Lower Thames Crossing

1.6 The Errata Report (Clean version)

Planning Inspectorate Scheme Ref: TR010032
Application Document Ref: TR010032/APP/1.6

VERSION: 2.0

Appendix A HRA Figure 24

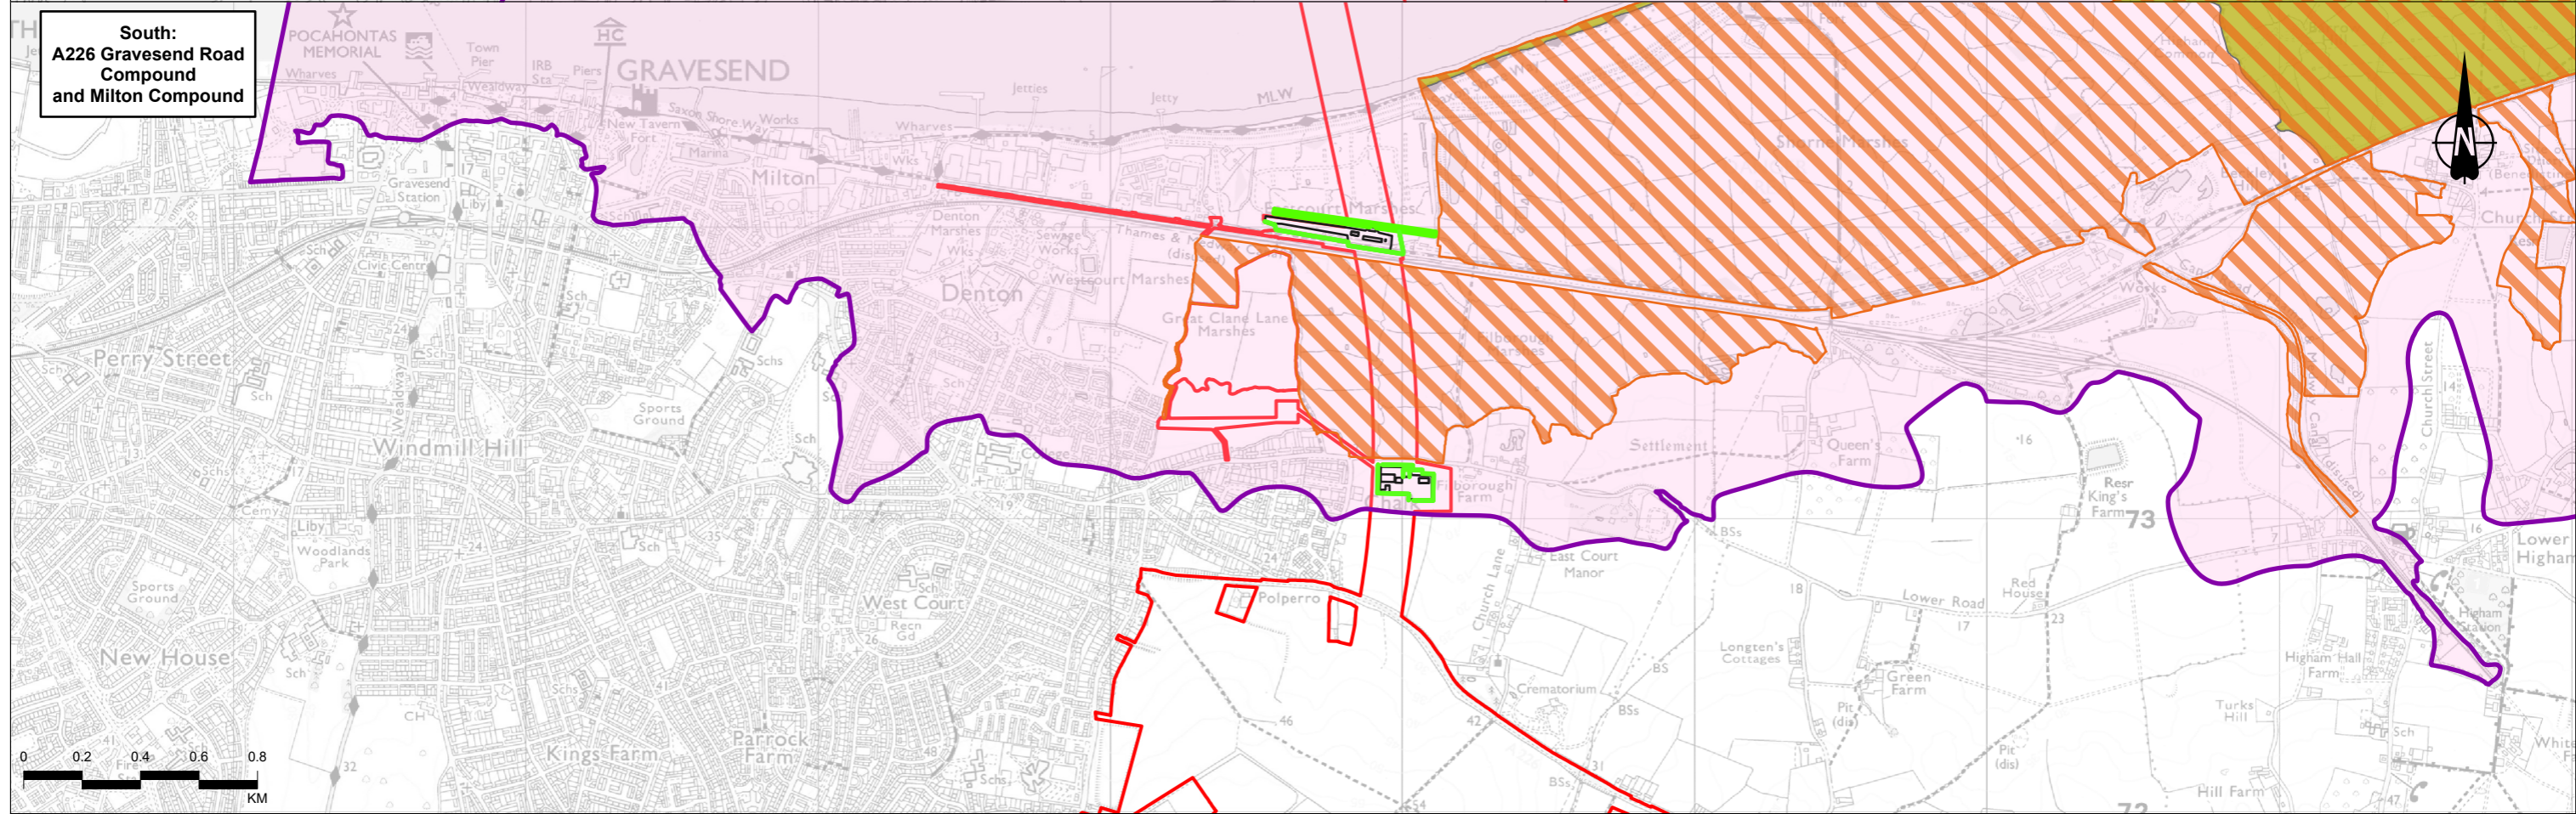
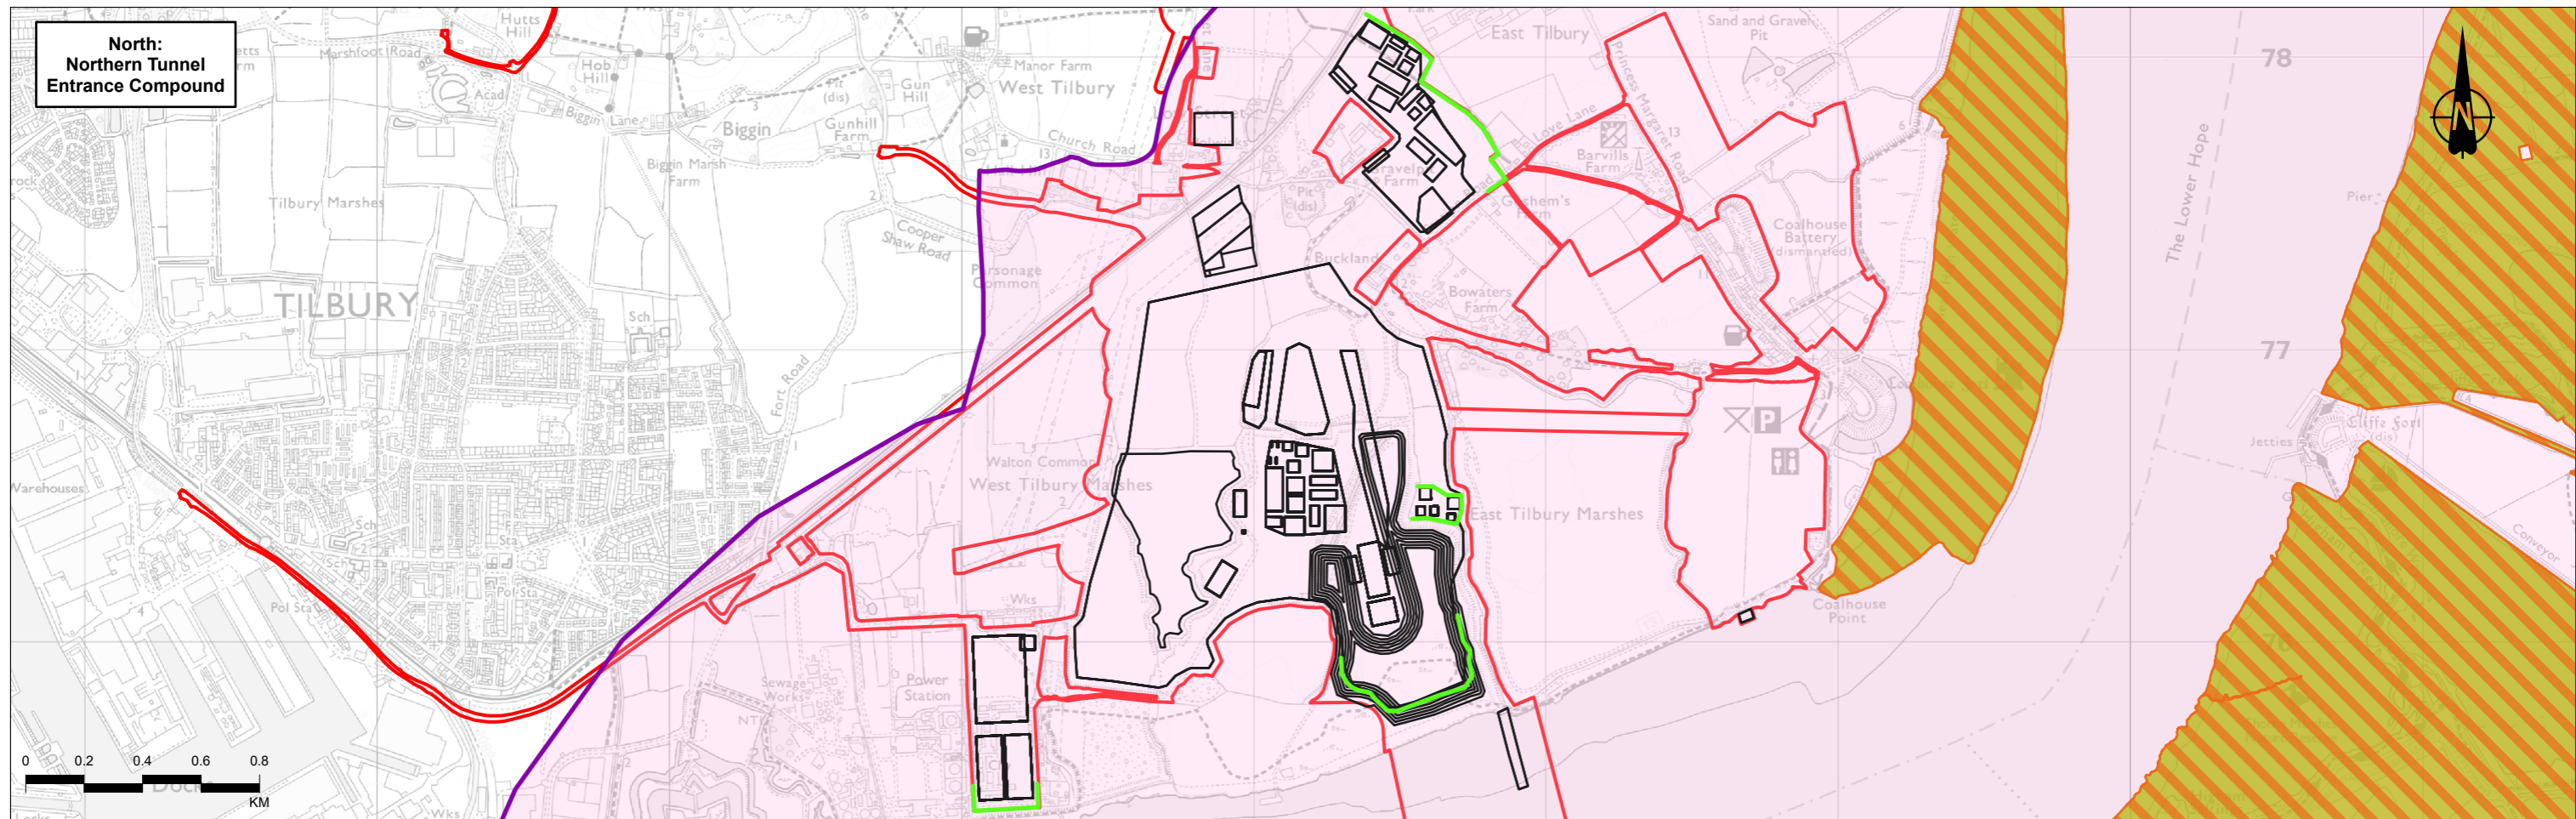
Application Document Reference	Errata identified at	Document Name	Section (page, paragraph)	Nature of Erratum and explanation	Correction	Commentary for Deadline 1
		Construction Practice, First iteration of Environmental Management Plan - Annex B - Outline Materials Handling Plan	Paragraphs: 4.2.5, 8.2.3 and 8.2.38		4km from Hoo Junction to southern portal tunnel entrance compound and approximately 11km to the A2 compound (due to HGV bans on some roads in Shorne)	
APP-487	S51 Dec 2022	Habitats Regulations Assessment Screening Report and Statement to Inform an Appropriate Assessment	Appendix A Figure 24	North view not showing all of noise attenuation measures	North view rescaled to show all noise attenuation measures	Figure updated and found in Appendix A of this document.
APP-487	D1	Habitats Regulations Assessment - Screening Report and Statement to Inform an Appropriate Assessment	Figure 24	Figure missing	Figure is cut off and does not include the full extent of proposed construction noise barriers	Figure updated and found in Appendix A of this document.

Status	PINS SUBMISSION		Original Size	A3	Revision	P04
Application Document Number	TR010032/APP/6.5		Scale	1:22,000		
Drawing Title	Figure 24 - Location of the Noise Attenuation Measures - Construction					
Drawing Number	HE540039-CJV-EBD-SZP_EGNE0000000-DR-LE-60086
